**VILLAGE OF WINDSOR
VILLAGE BOARD RESOLUTION 2016-41**

**APPROVAL OF PRELIMINARY PLAT FOR
HAPPY VALLEY ADDITION TO WINDSOR GARDENS**

TO: Village of Windsor Plan Commission
CC: Robert Wipperfurth, Tina Butteris, Amy Anderson Schweppe, Kevin Richardson, Connie Anderson
FROM: Jamie Rybarczyk, Planning Consultant
RPT DATES: March 17, 2016
MTG DATES: March 24, 2016
APRVL DATE: N/A
FOTH FILE: 16W027.01/06
RE: Happy Valley Addition to Windsor Gardens - Preliminary Plat Request

PRELIMINARY PLAT OF HAPPY VALLEY ADDITION TO WINDSOR GARDENS

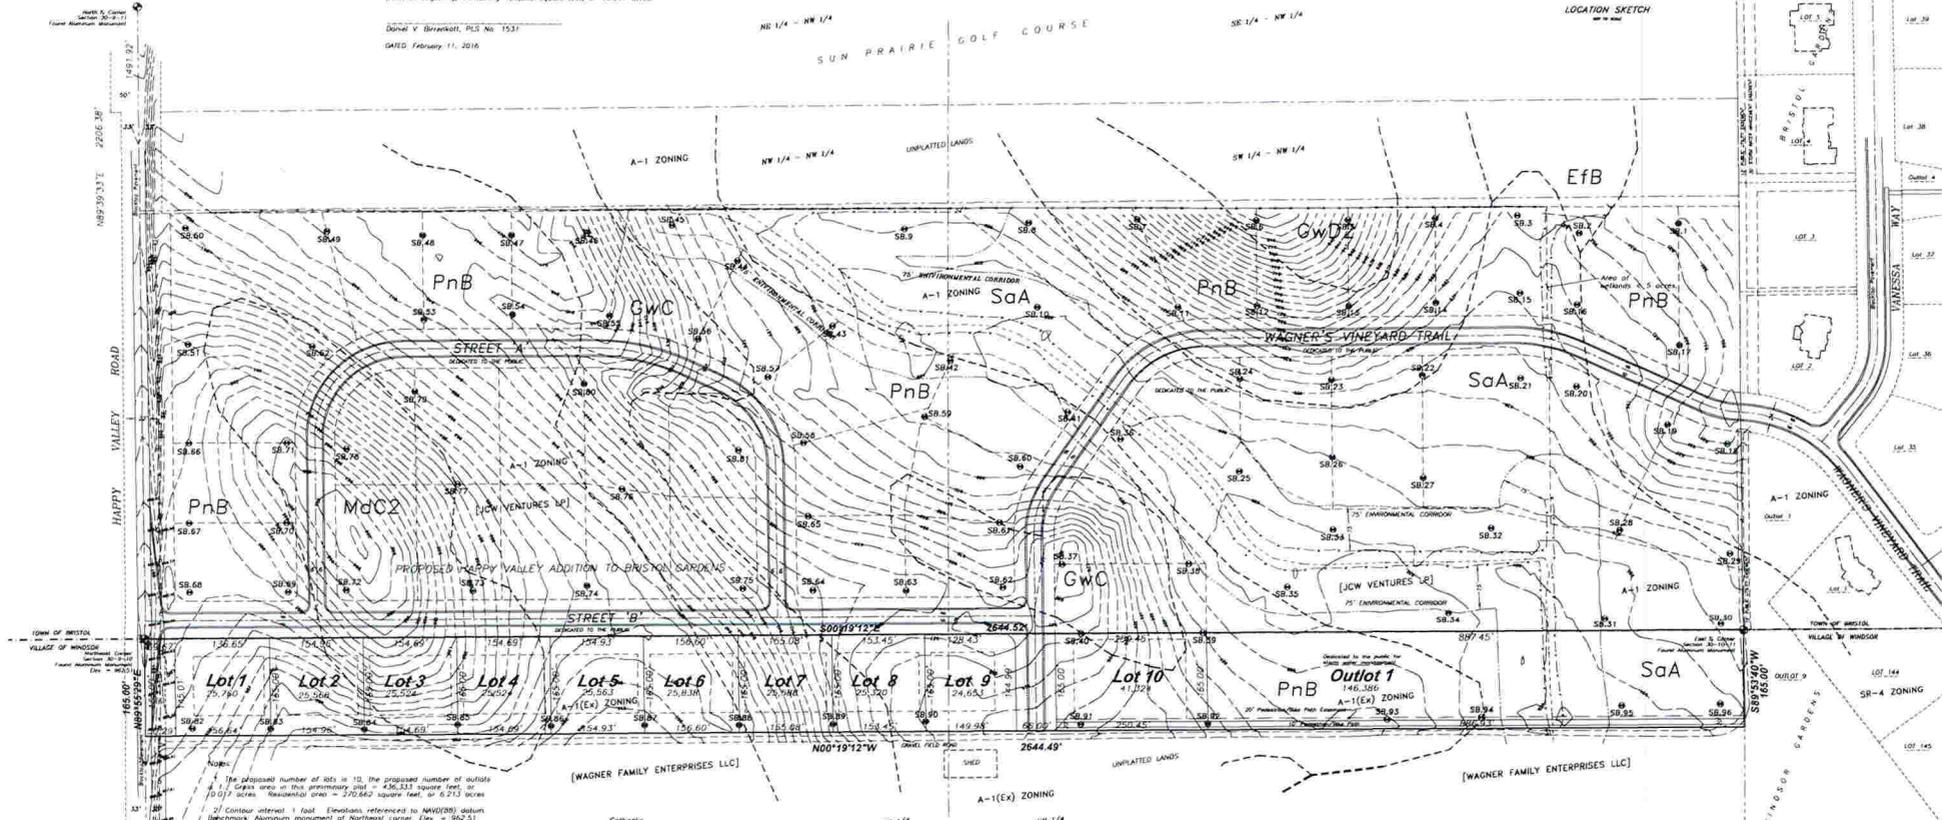
4. The Preliminary Plat illustrates the extension of Wagner's Vineyard Trail west of Street B between Lot 9 and Lot 10. This extension dead-ends into the Village of Windsor's Agricultural Preservation / Agricultural Enterprise Area. This area is not intended for residential development; therefore, the extension of Wagner's Vineyard Trail west of Street B should be removed. As a result, Lot 10 will need to be reconfigured to have sufficient lot width on Street B or Wagner's Vineyard Trail.

1. Note #9 shall state: Current zoning is AG-35ac, Agricultural District. Proposed zoning is ER, Estate Residential District.
